1. SUBMITTAL TYPE: (Is this a resubmittal? Yes ☐ No ☒)			
Deferred Submittal ☐	Addendum Number: 01	Revision Number:	CCD Number: Category A ☐ or B ☐
2. PROJECT INFORMATION:			
School District/Owner: San Beranrdo City USD		DSA File Number: 36 H7	
Project Name/School: Indian Springs HS - Health Center		DSA Application Number 04 123900

ADDENDUM NO. 1

Indian Springs High School – Health Center

DSA #04-123900 FILE #36-H7 RCA Project No. 1-78-50

PLUMBING DEMOLITION FLOOR PLAN

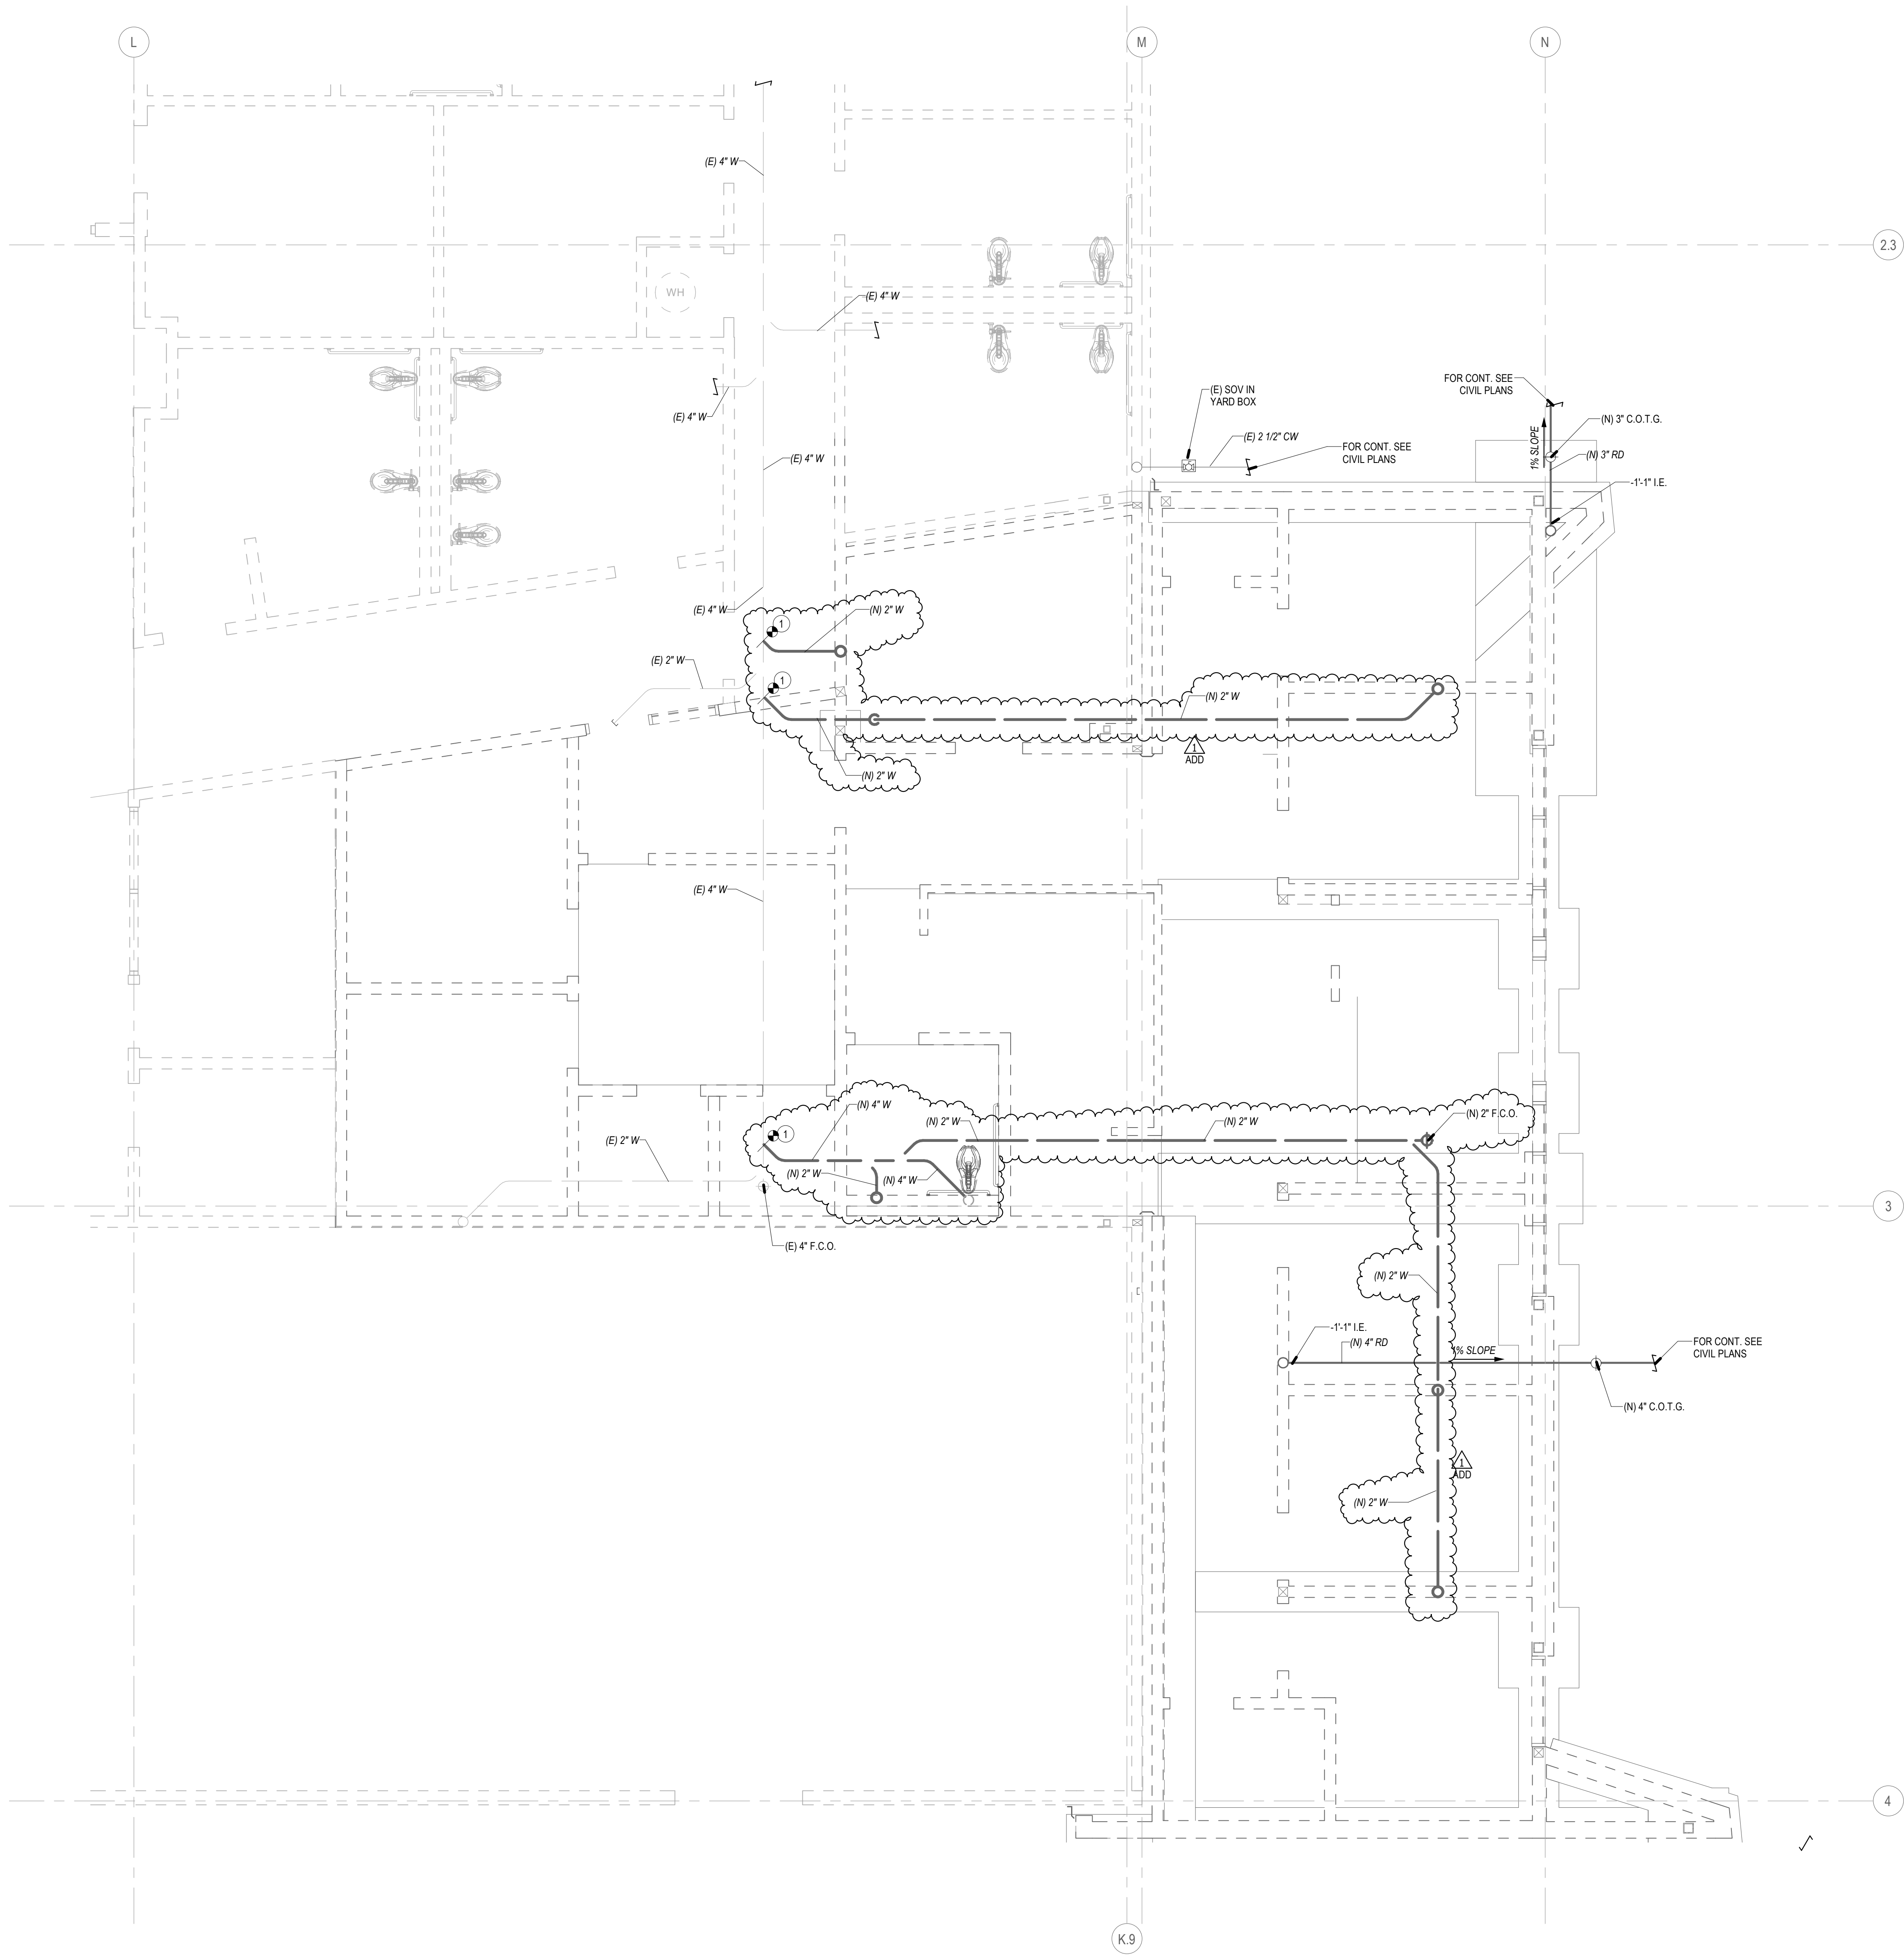
Item No. 1.35 Reference Sheet P1-1.1 - PLUMBING DEMOLITION FLOOR PLAN
1.35.1 Replace Sheet P1-1.1 and revise per clouded areas & items listed below:
 (a) Revised HW, HWR & CW piping demolition scope

PLUMBING ROOF PLAN

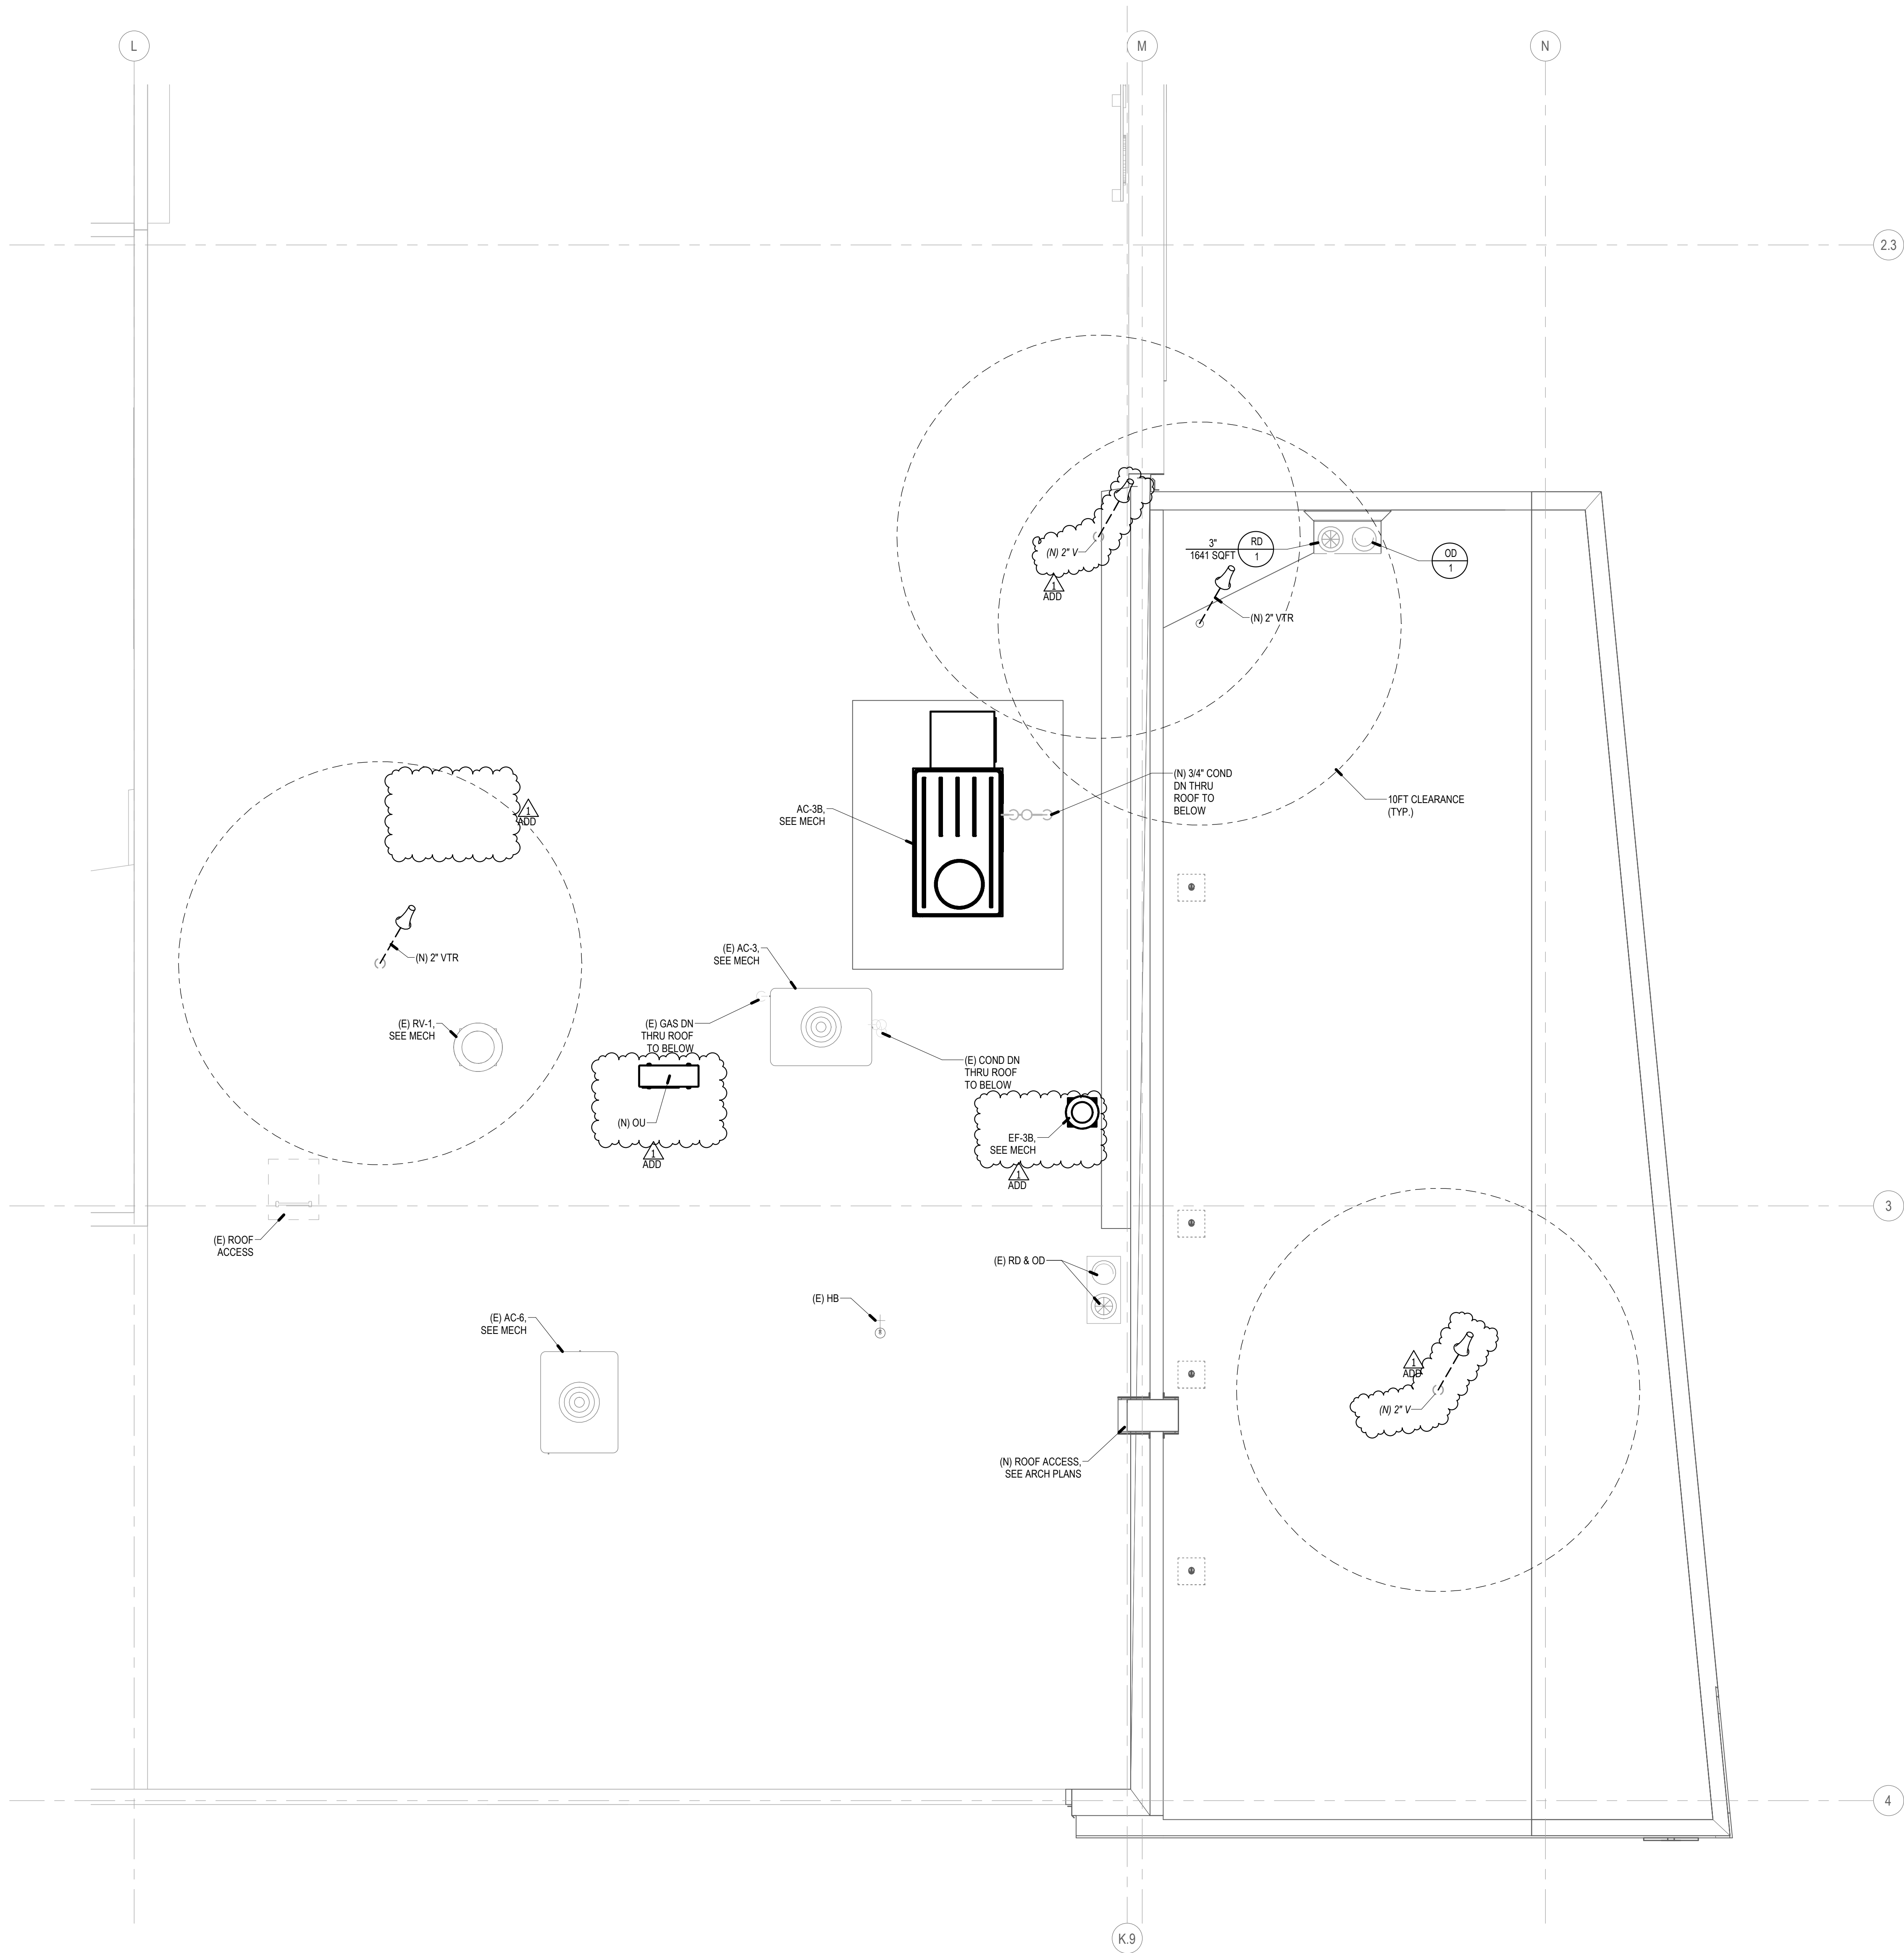
Item No. 1.39 Reference Sheet P1-2.3 - PLUMBING ROOF PLAN
1.39.1 Replace Sheet P1-2.3 and revise per clouded areas & items listed below:
 (a) Added New VTRs

1 LIGHTING PLAN
1/8" = 1'

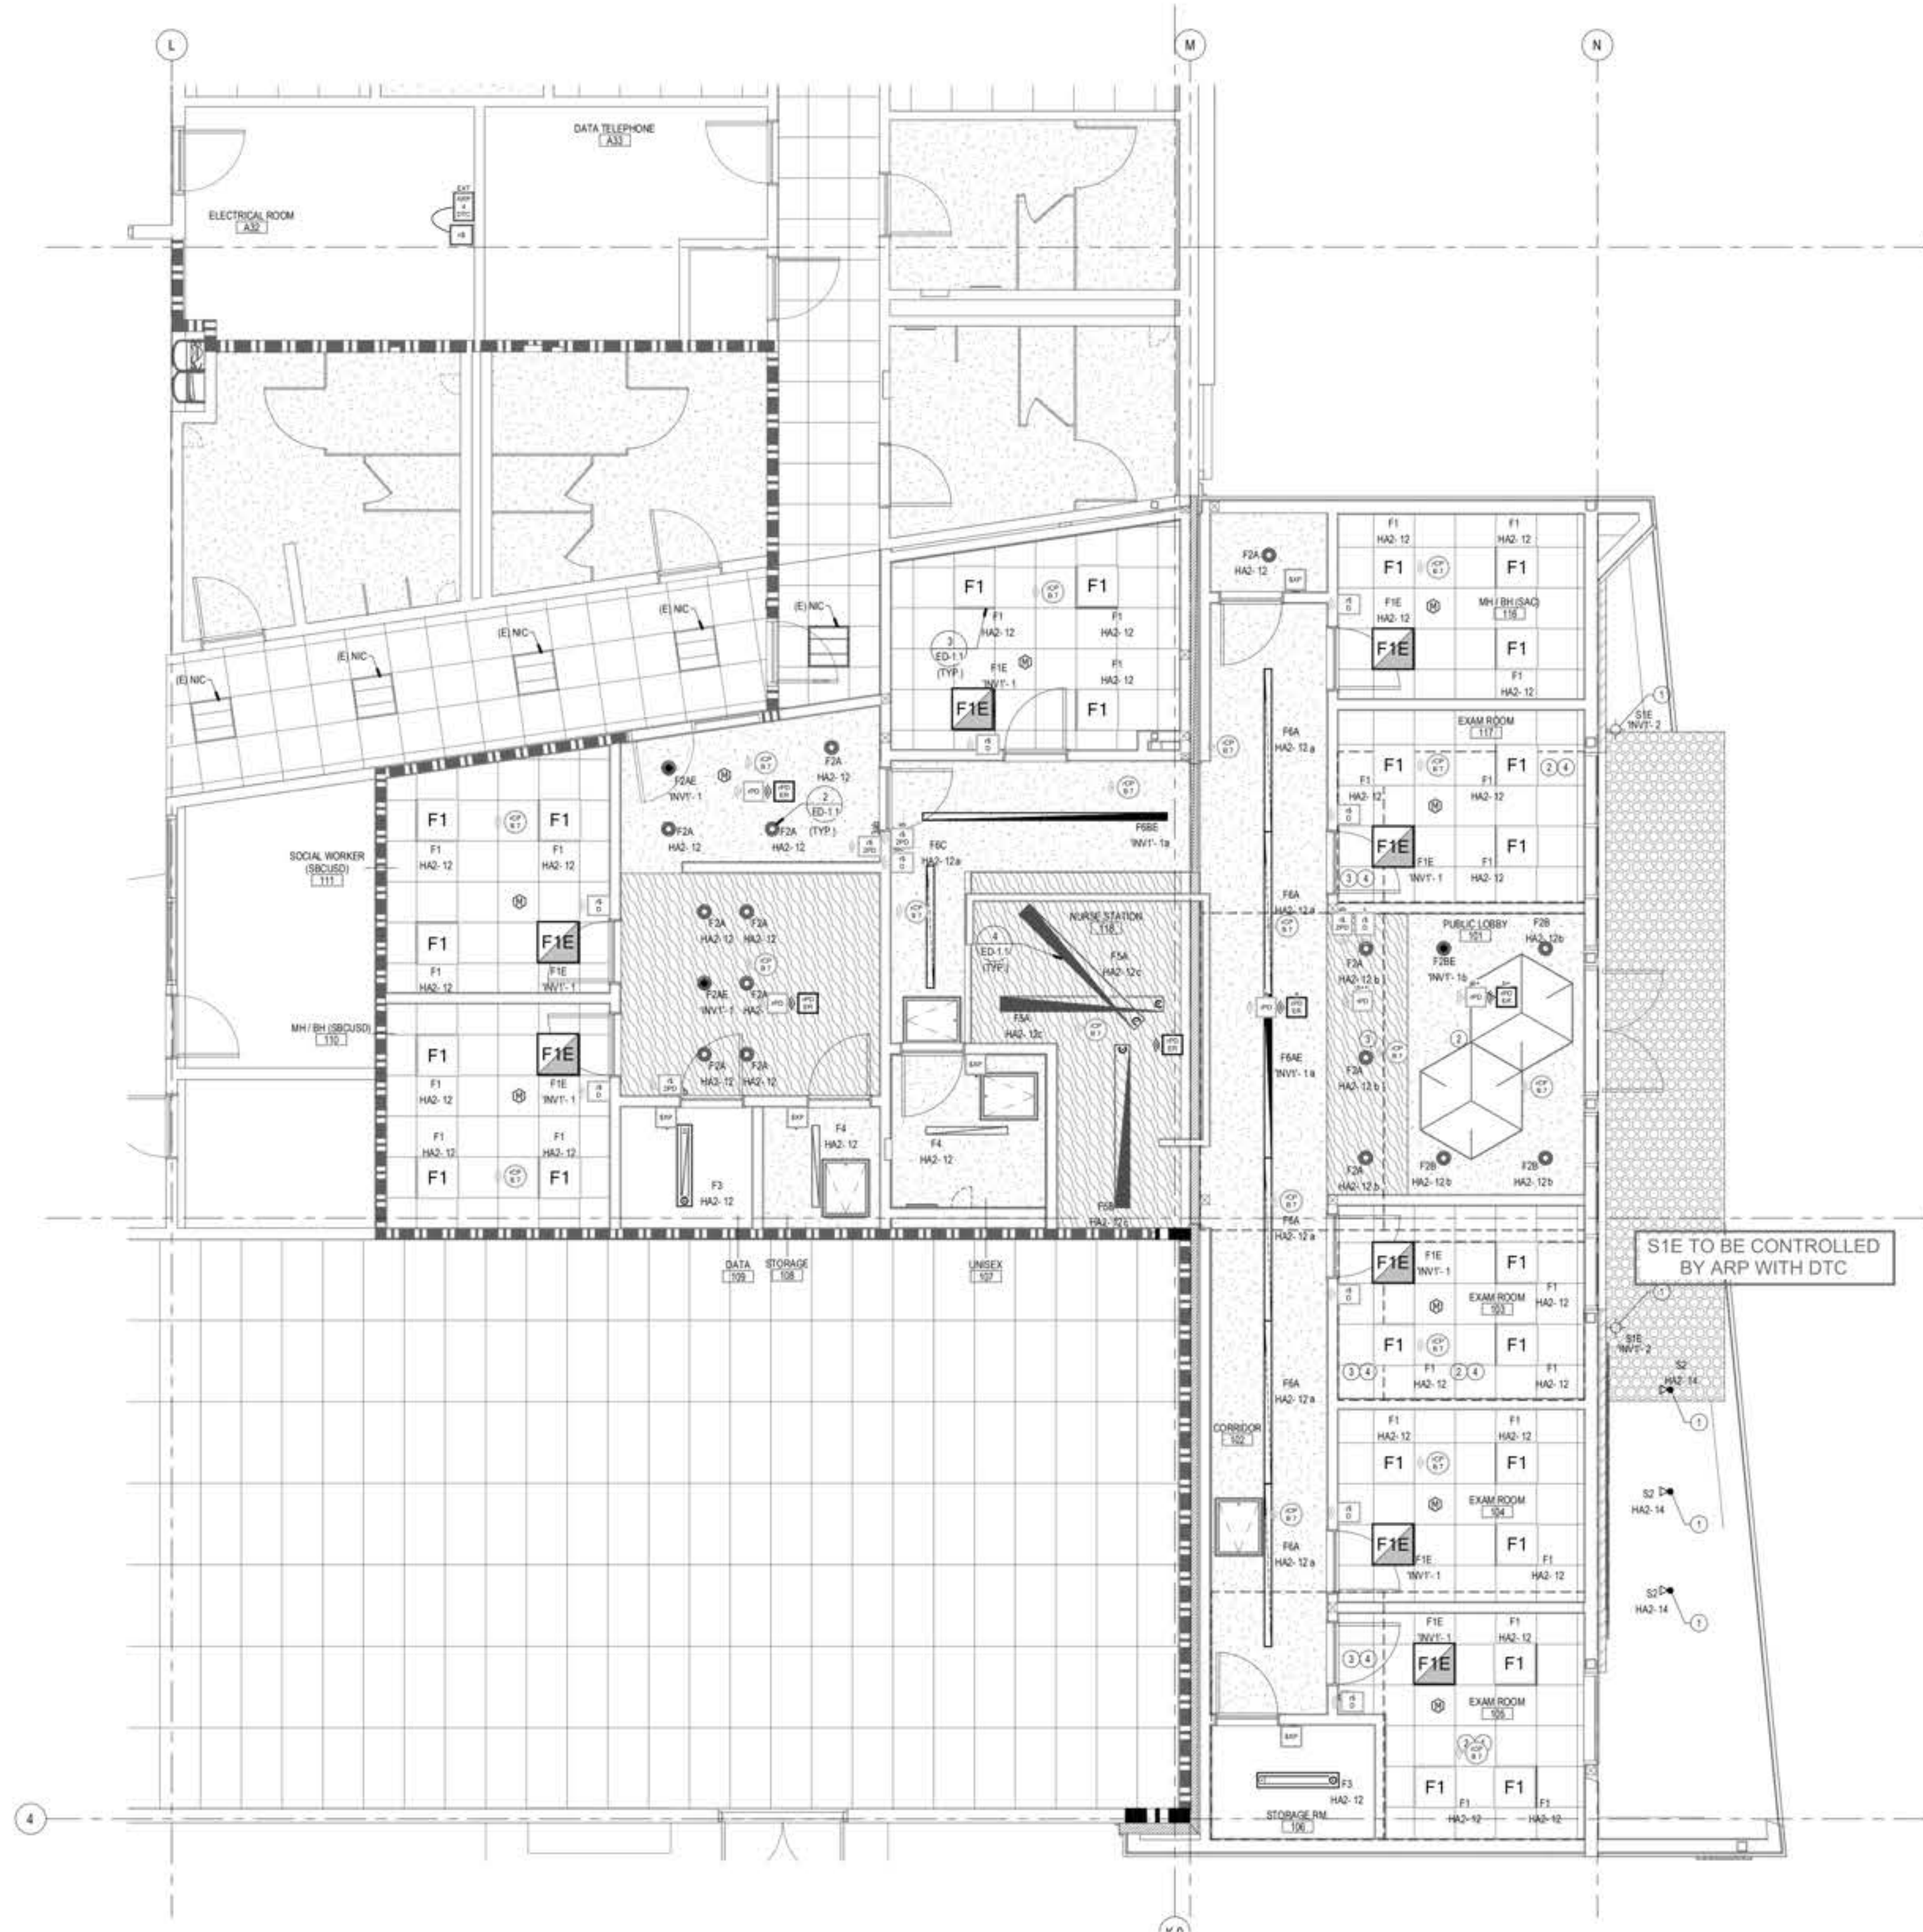
(b) EF-3B has been relocated to a new location near the east edge of the roof.
 (c) OU-1 has been added to the roof plan.
- Item No. 1.49 Reference Sheet E1-3.1 - LIGHTING REMODEL PLAN

1.49.1 Replace Sheet E1-3.1 and revise per clouded areas & items listed below:
 (a) The Lighting Remodel Floor Plan has been updated to reflect the revised ceiling plan layout, with the removal/addition/relocation of light fixtures and control devices.
